**Historic Preservation Services**  
Community Development & Neighborhood Services  
281 N. College Ave.  
Fort Collins, CO 80524  
**970.224.6078**  
[preservation@fcgov.com](mailto:preservation@fcgov.com)  
[fcgov.com/historicpreservation](http://fcgov.com/historicpreservation)

**REPORT OF ALTERATIONS TO DESIGNATED RESOURCE**  
**Site Number/Address: 608 Peterson St.**  
**Laurel School National Register Historic District**  
**ISSUED: July 31, 2025**

The alterations include: Second story demolition in preparation for a pop-top addition

EXISTING AND DEMO UPPER FLOOR PLAN

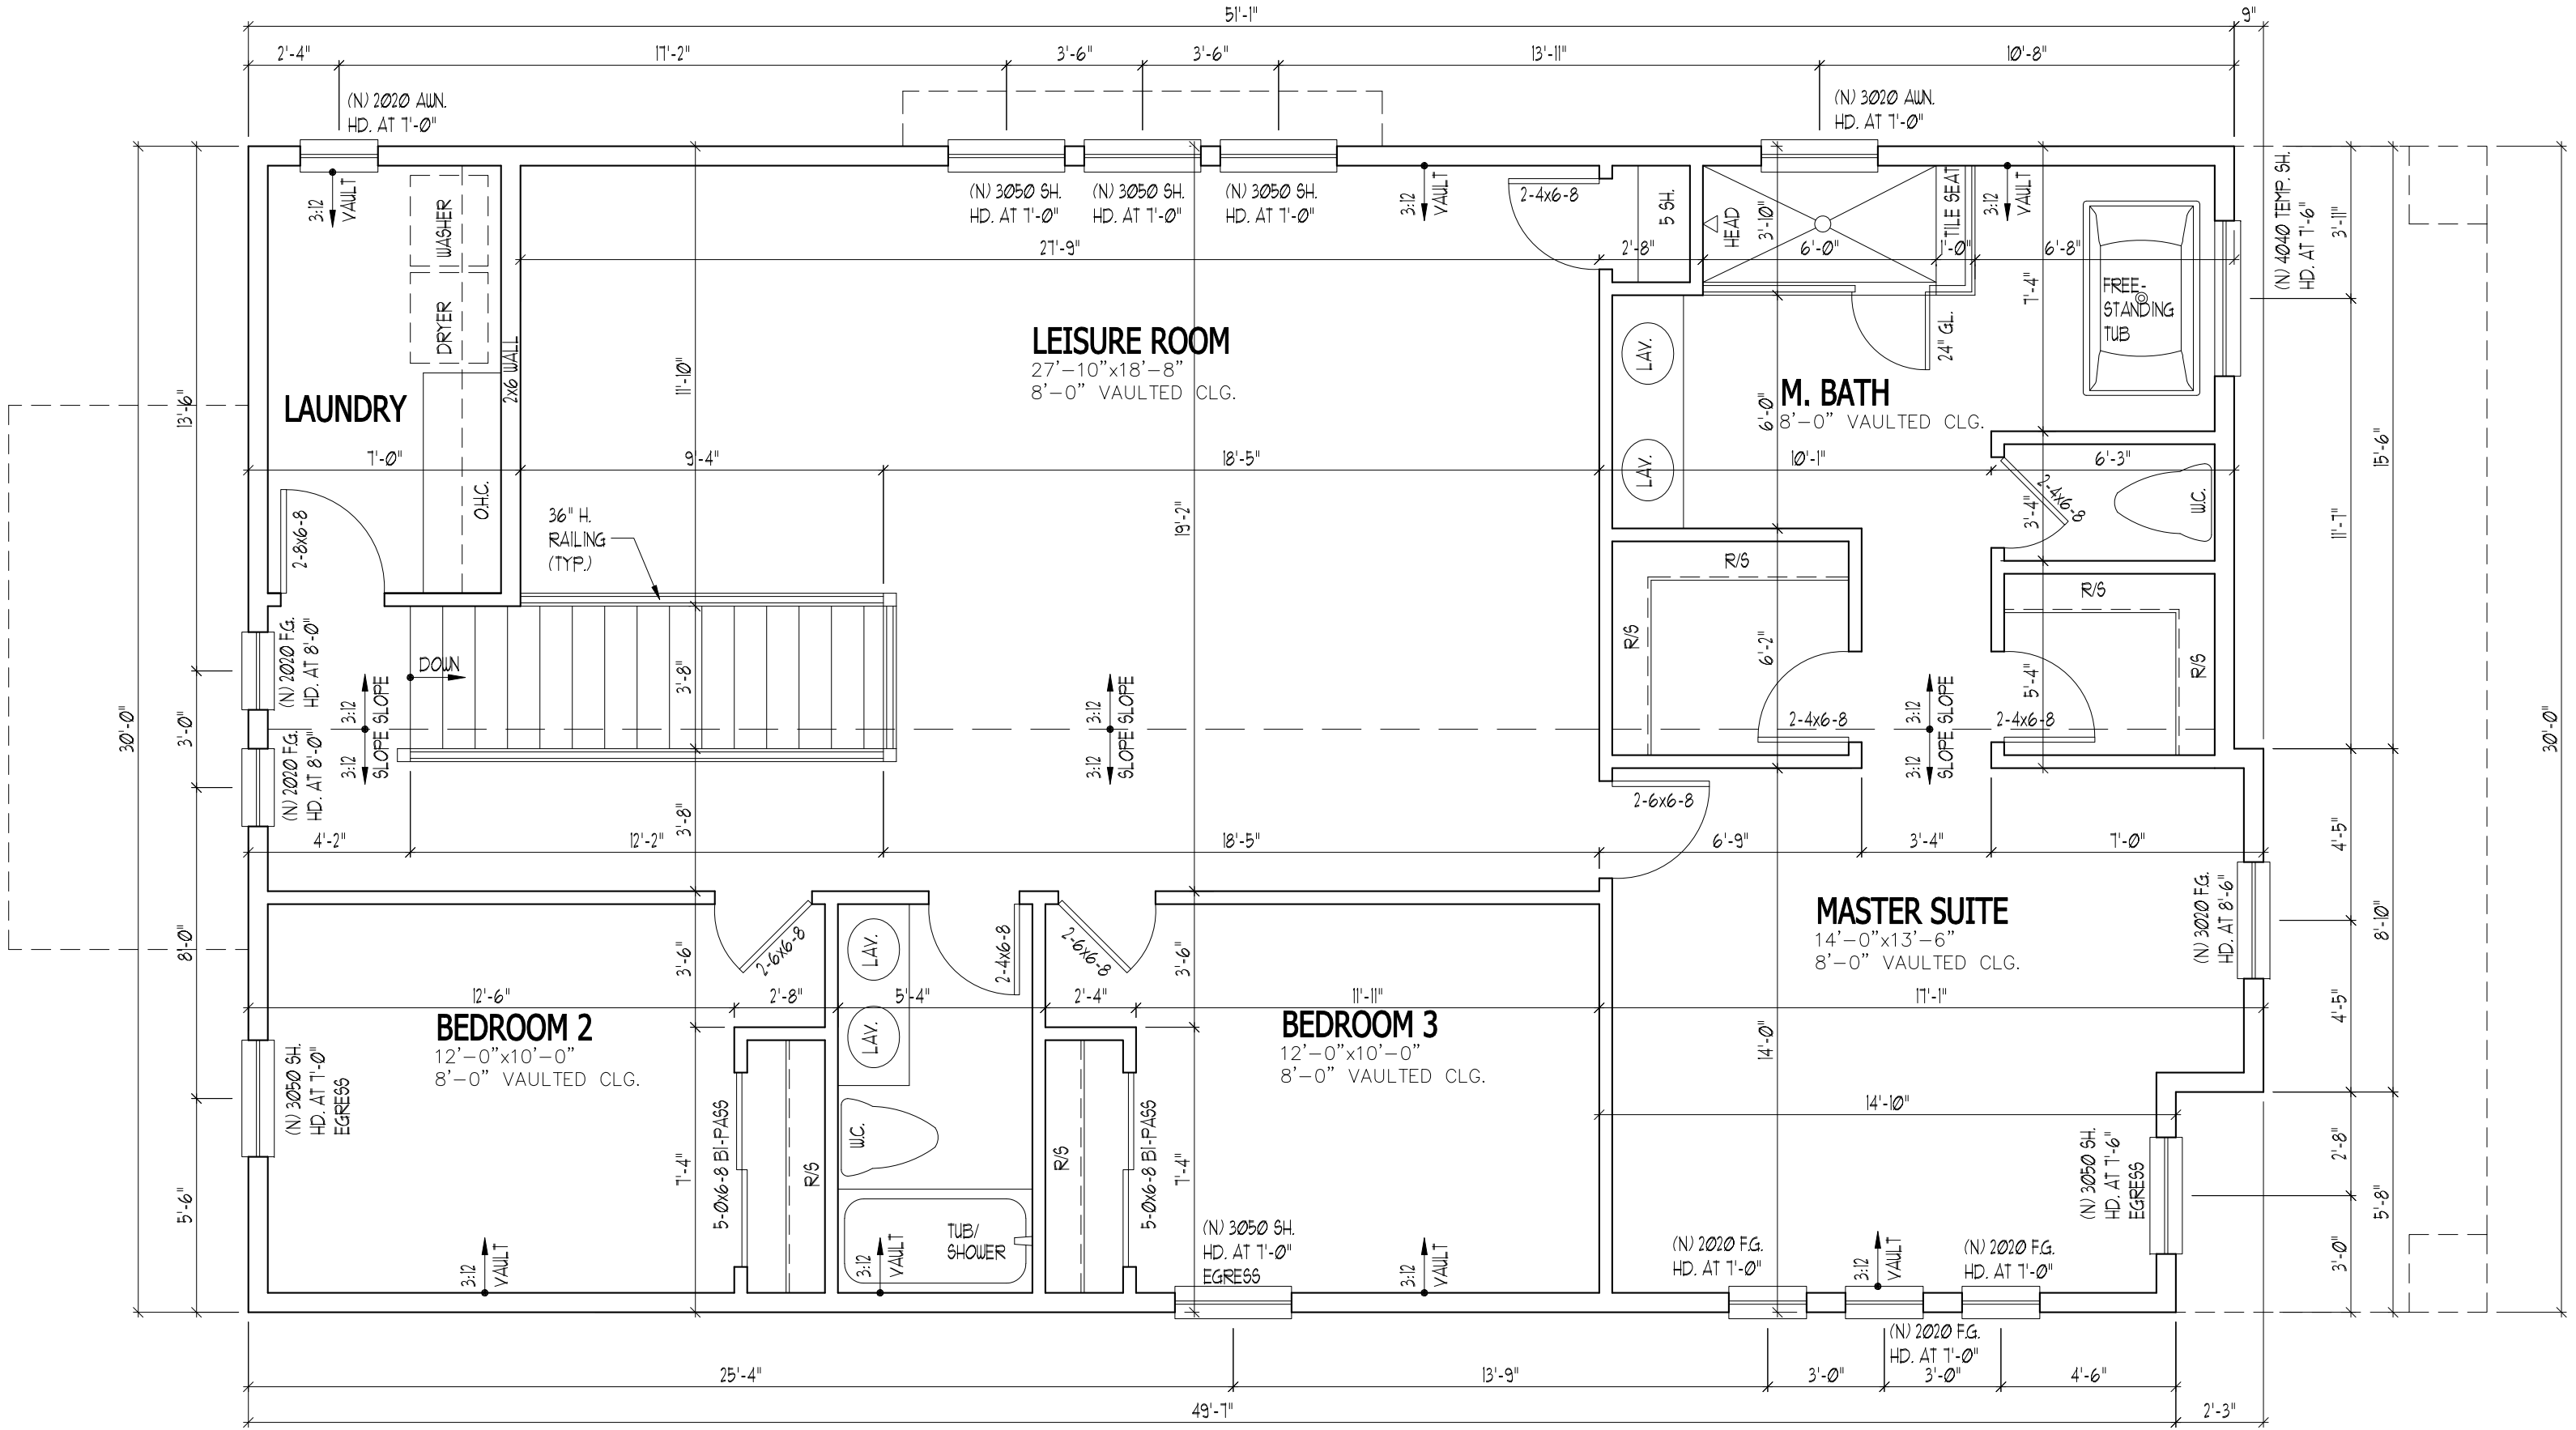
Our staff review of the proposed work finds the alterations do not meet the [SOI Standards for Treatment of Historic Properties](#). A summary is provided below:

<b>Applicable Code Standard</b>	<b>Summary of Code Requirement and Analysis (Rehabilitation)</b>	<b>Standard Met (Y/N)</b>
<b>SOI #1</b>	<i>A property will be used as it was historically or be given a new use that requires minimal change to its distinctive materials, features, spaces, and spatial relationships;</i>  <b>The residential use of the property will not change as part of this project.</b>	<b>Y</b>
<b>SOI #2</b>	<i>The historic character of a property will be retained and preserved. The removal of distinctive materials or alteration of features, spaces, and spatial relationships that characterize a property will be avoided.</i>  <b>The Littlefield Residence is a c. 1910 single-story frame residence with decorative half-timbering in the gable end. This project phase includes removal of second story material to prepare for a pop-top addition. The removal of this material changes the character of the home, and so this Standard is not met.</b>	<b>N</b>
